Has the placement of turbines in the Jupiter proposal been guided by best practice or desperation?

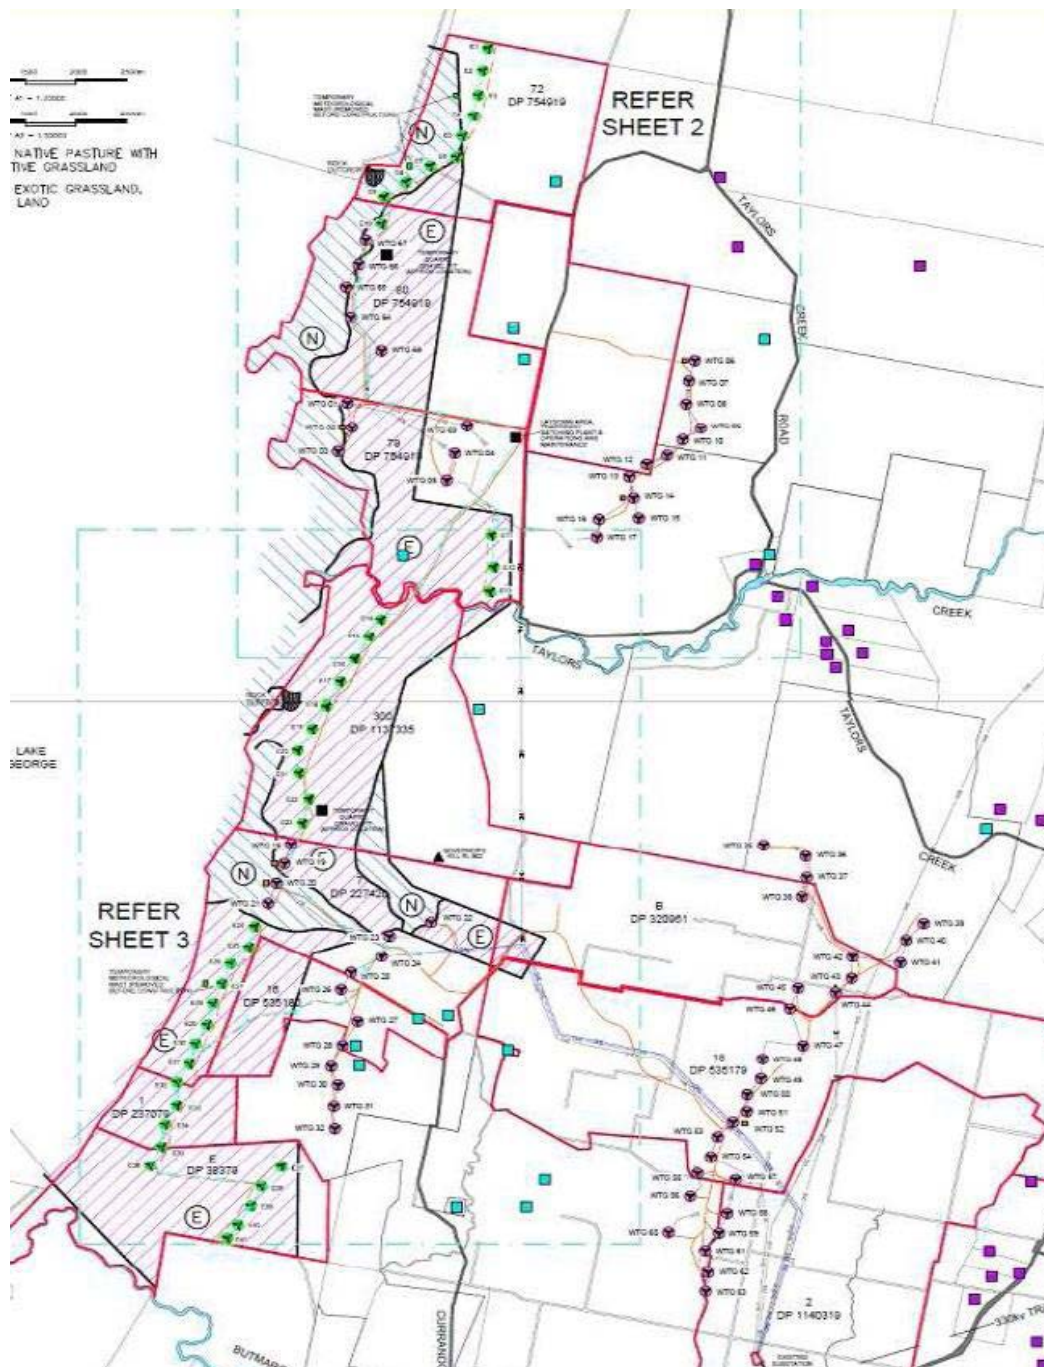
Wind turbines create wake turbulence. In Annex J, Aeronautical Assessment Report, this wake turbulence created by a wind turbine is of such magnitude, that a zone of influence exists (for the purpose of aircraft activity) of 16D (rotor diameters or 2.016Km) downstream from the turbine rotor.

Clearly, for this turbulence to have a causal affect 2km downstream for aircraft, it is of significant magnitude.

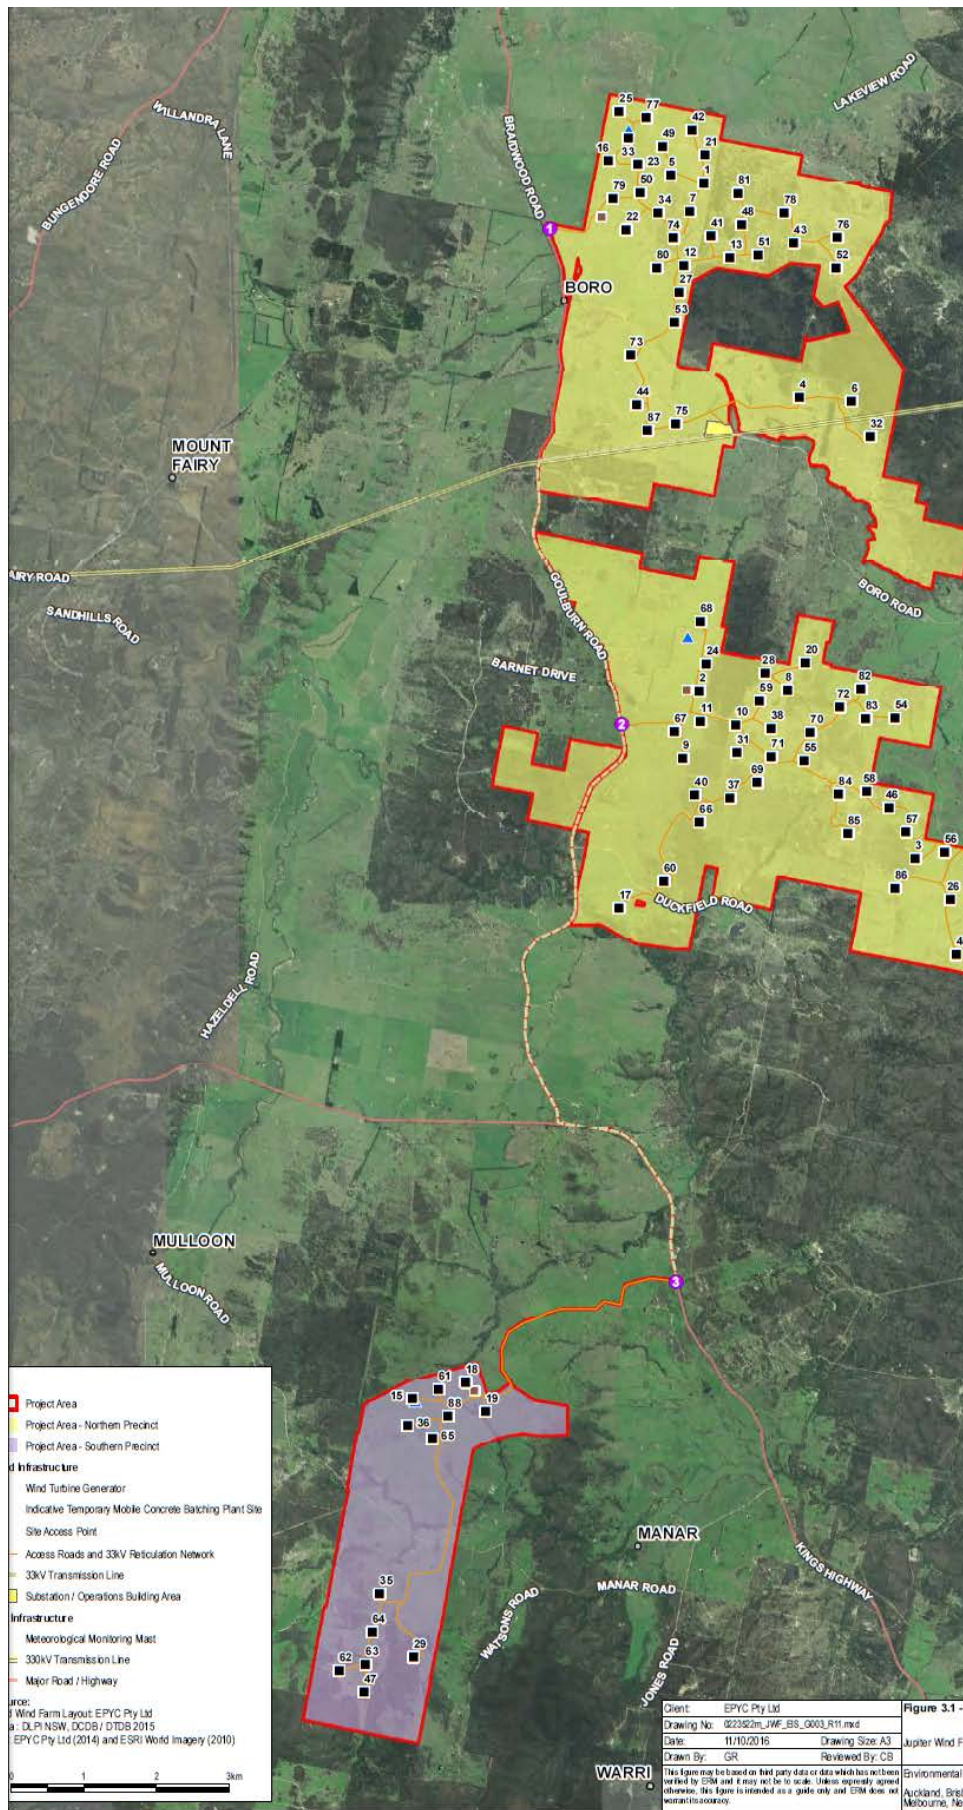
When analysing the Capital 1 and 2 layouts (below), it is clear that the general positioning of turbines is in a North-south direction, which places them in a line abreast of the prevailing wind. This is not by chance. Obviously the turbines have been placed in such a way as to ensure they receive a clean prevailing wind, which in turn allows them to operate at their most efficient, both for maximum output, minimum noise and internal wear that occurs through the operation within dirty wind.
